ADDENDUM NO. 01

BCDM Architects
1015 North 98th Street, Suite 300
Omaha, Nebraska 68114

November 30, 2023

Arnold Elementary – Addition & Renovation
5000 Mike Scholl Street
Lincoln, NE 68524
&
Huntington Elementary Renovation
2900 North 46th Street
Lincoln, NE 68504
BCDM Project No. 5370-01

FIRST FLOOR PLAN - HVAC DEMOLITION

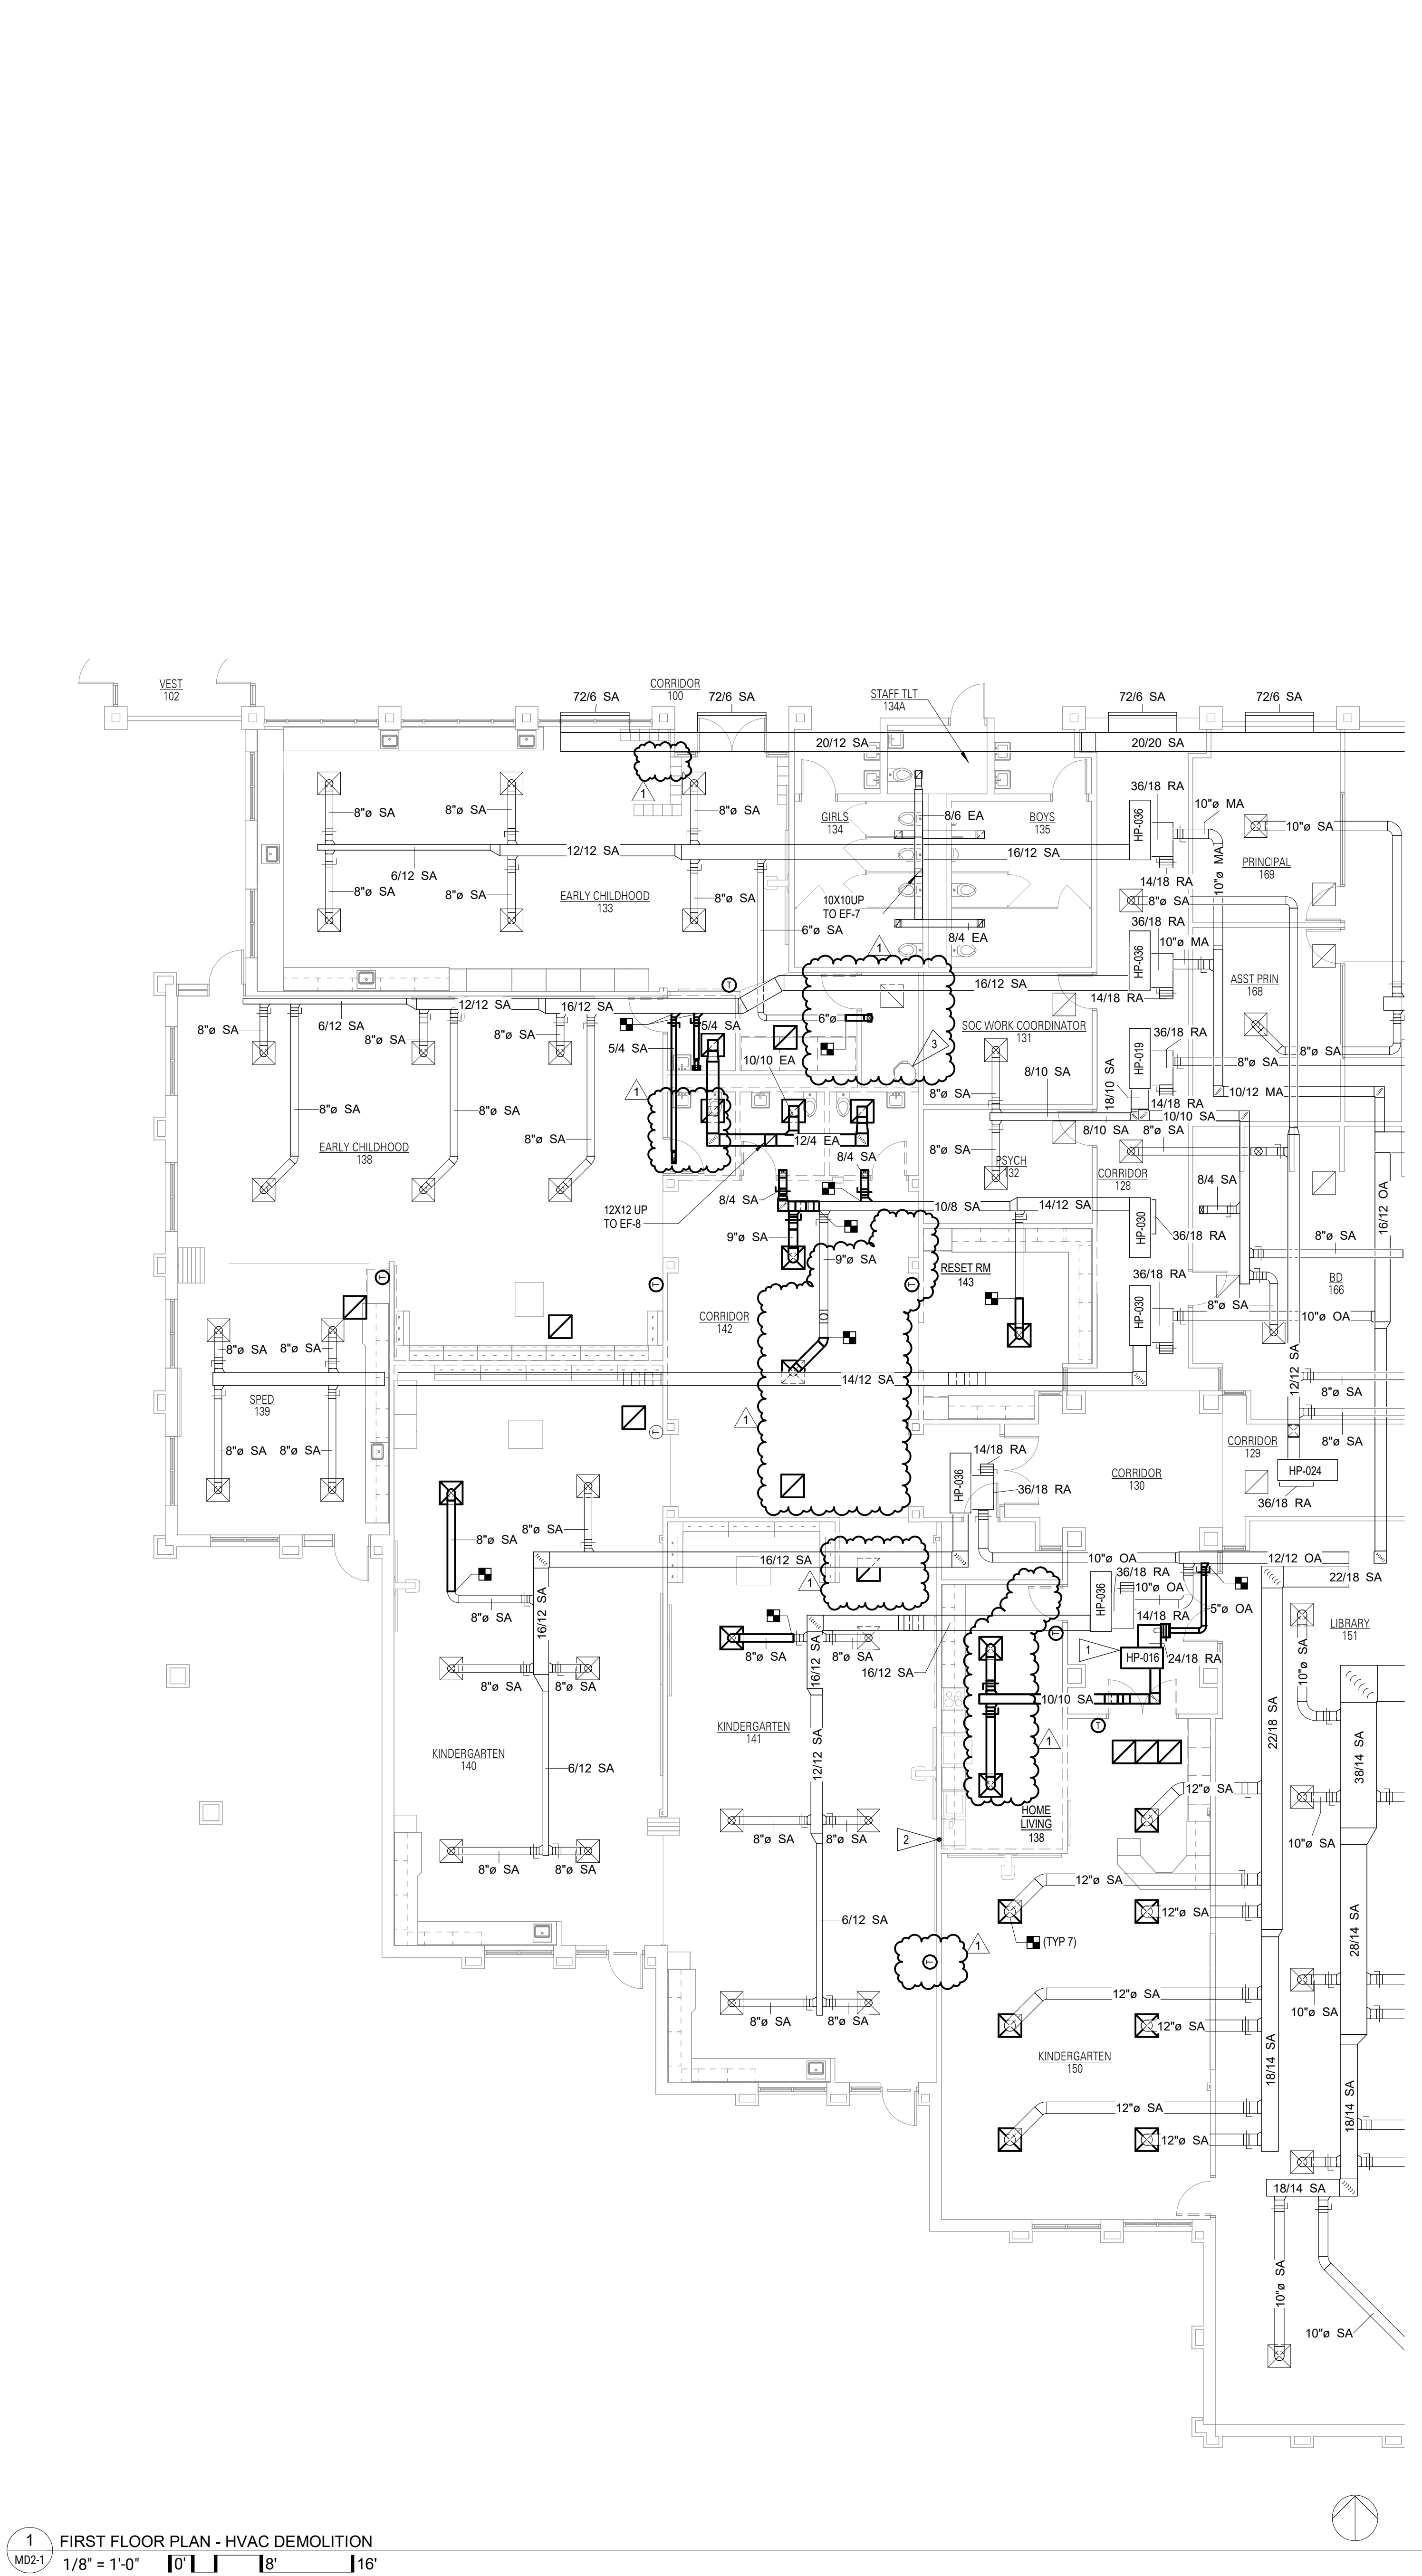
1MD2. Sheet MD2-1 – First Floor Plan – HVAC Demolition

1. Modify Floor Plan 1.
2. Flag Notes: Modify Flag Note 3.
3. See attached reissued sheet.

E1-1

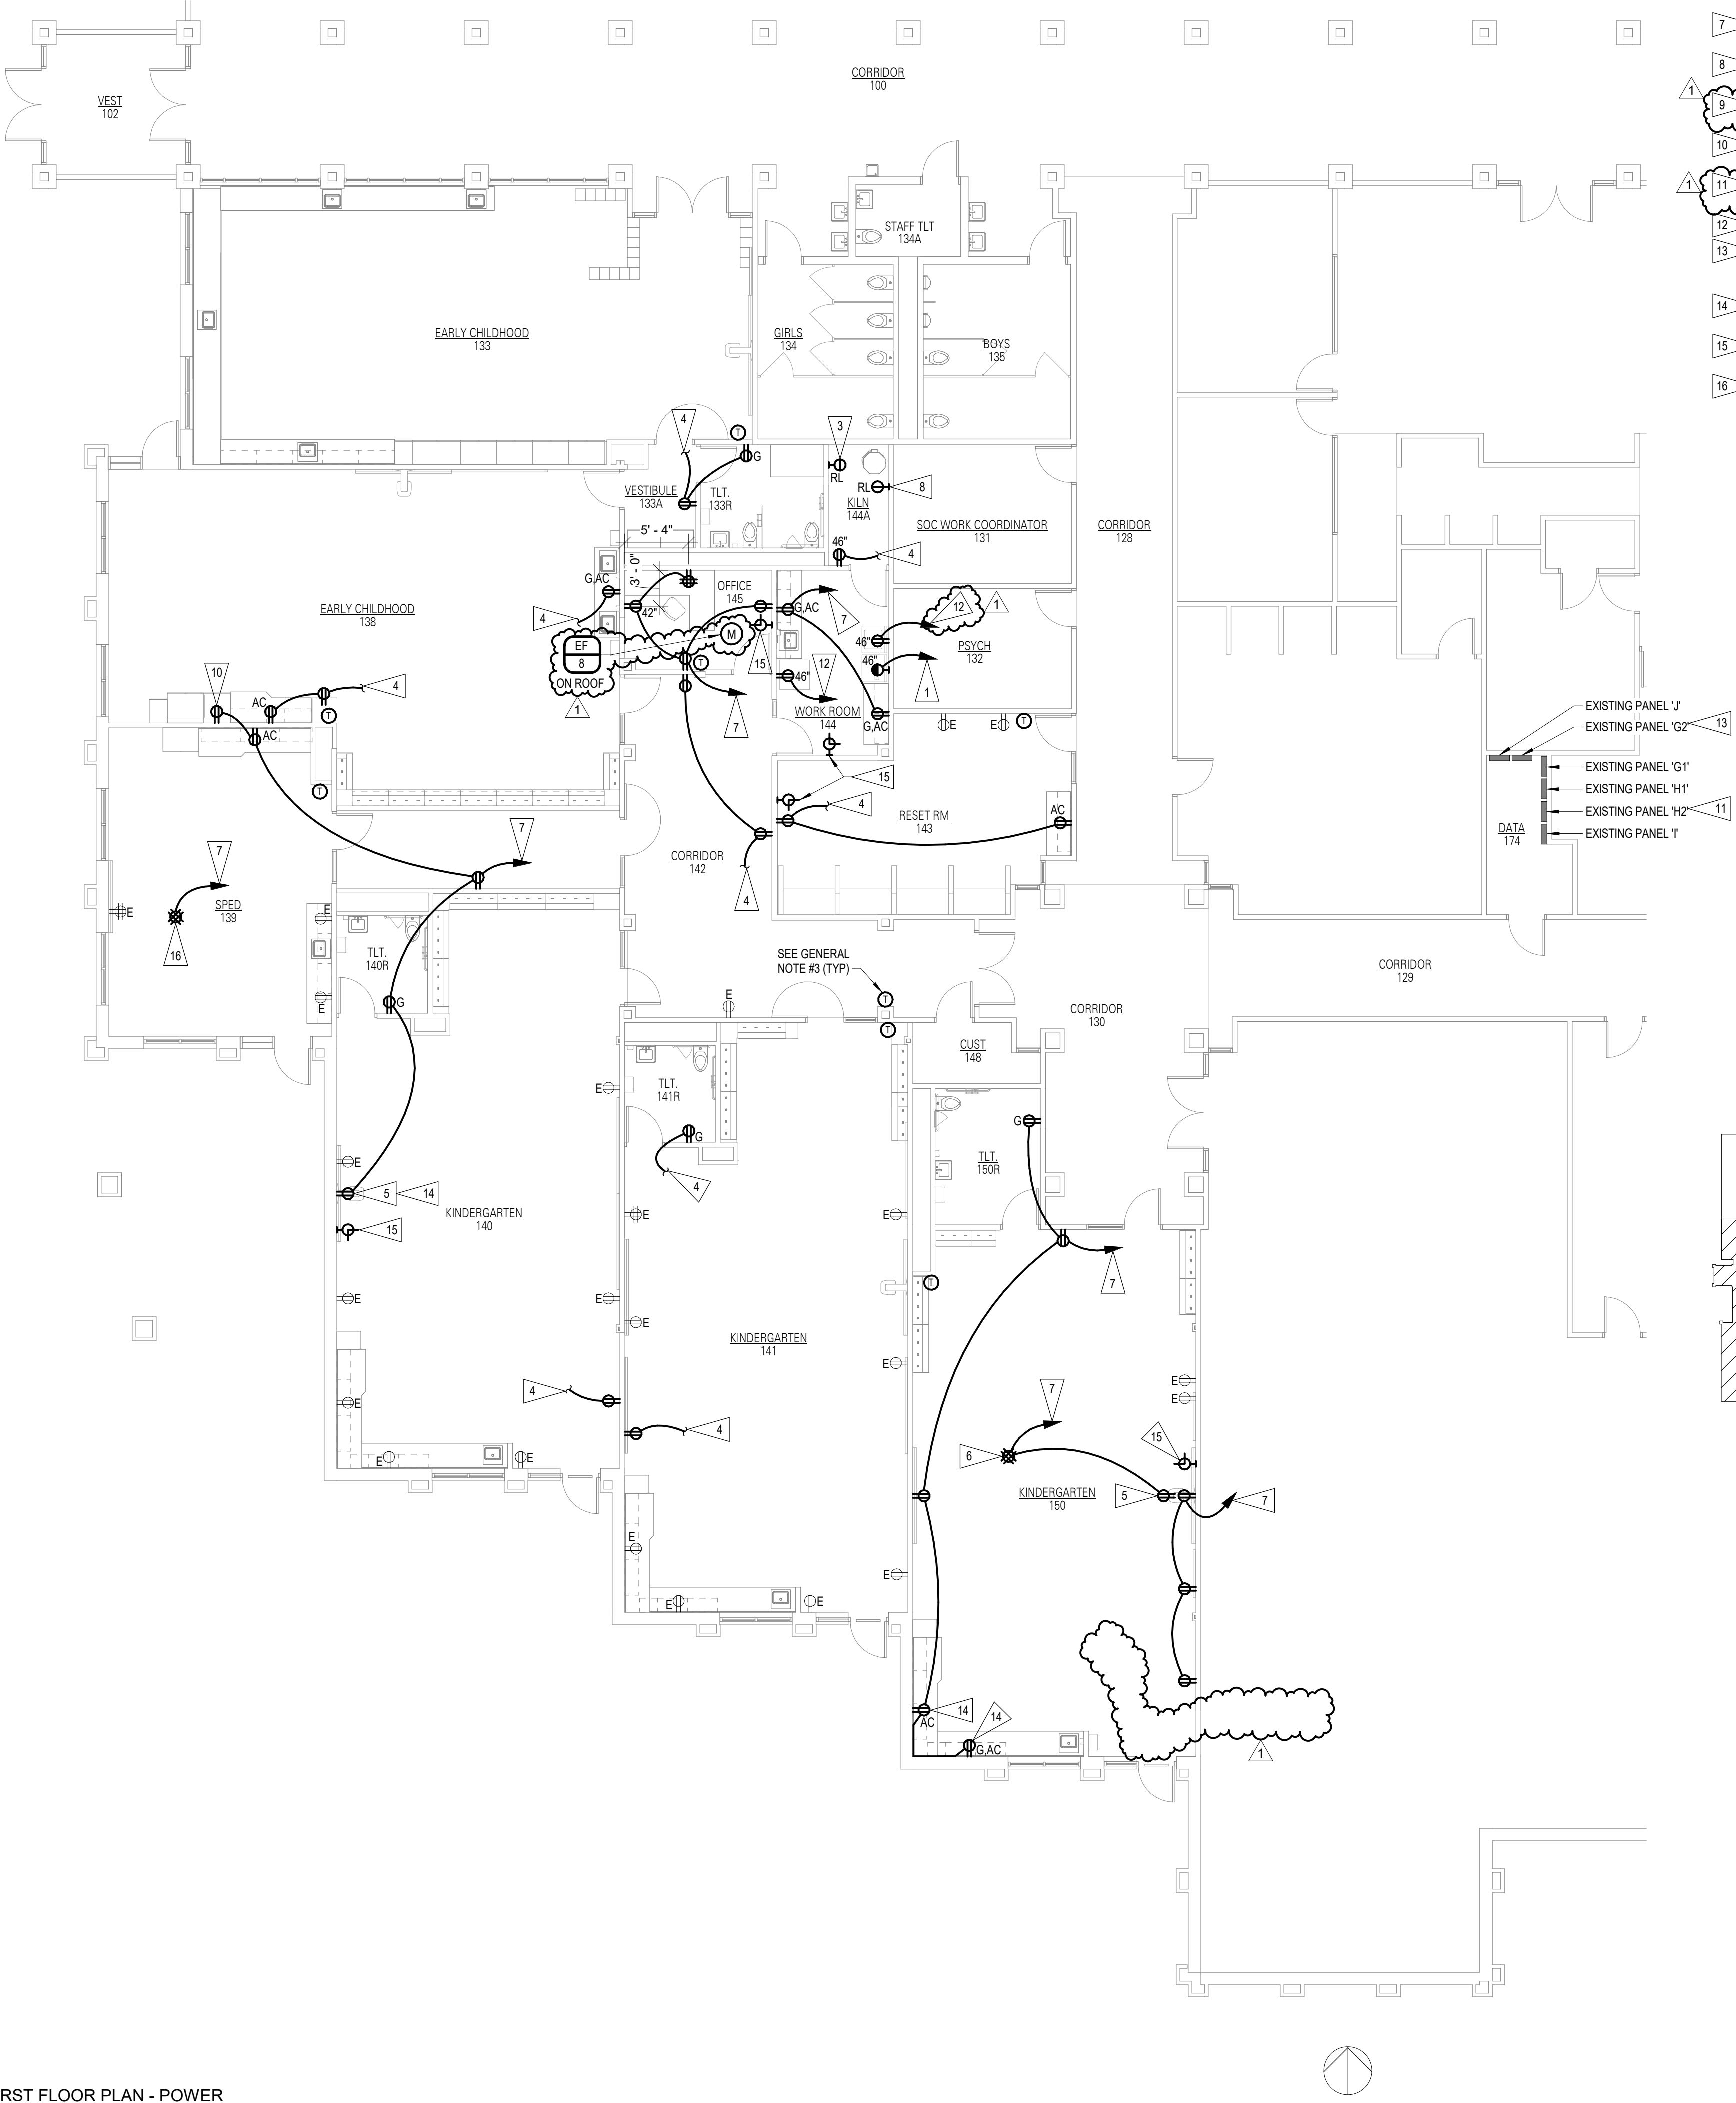
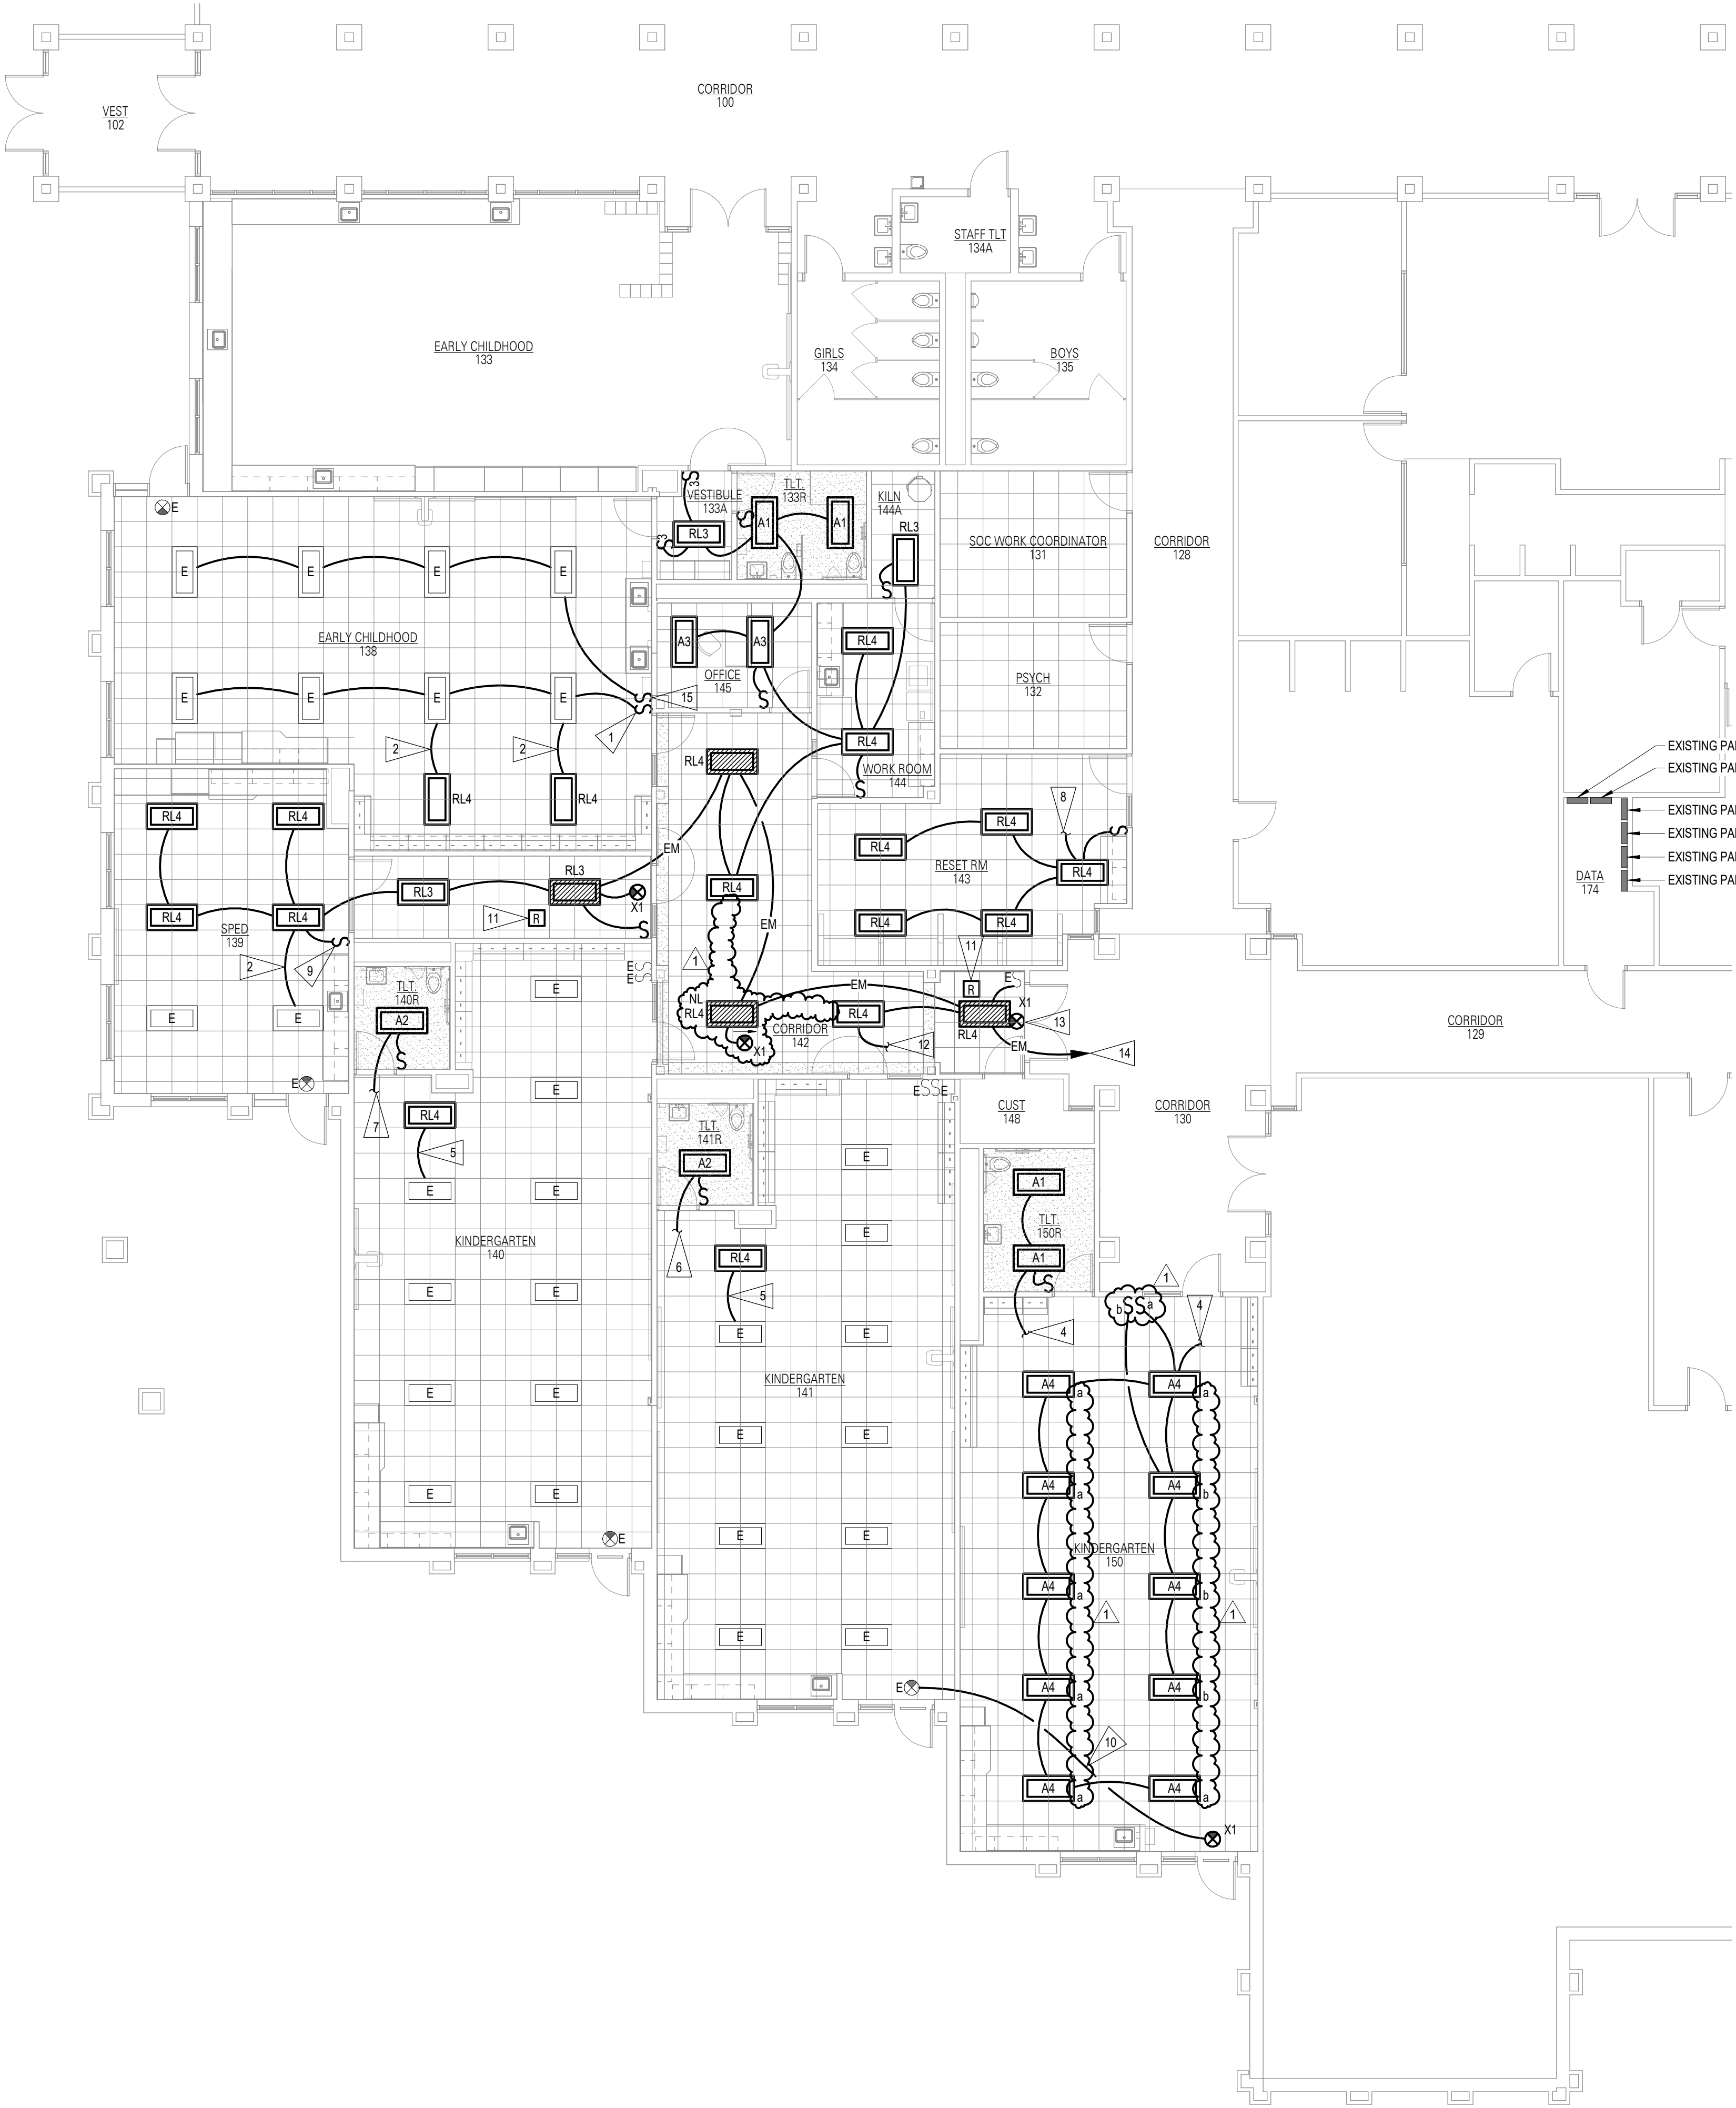
1ED2. Sheet E1-1 – First Floor Plan – Lighting, Luminaire Schedule

1. Kindergarten 150: Add subscripts to switches and luminaires to clarify switching intent.
2. Corridor 142: Modify southwest luminaire to be an unswitched night light.
3. Flag Notes: Delete Note 3 and make 'Not Used.'
4. See attached reissued sheet.
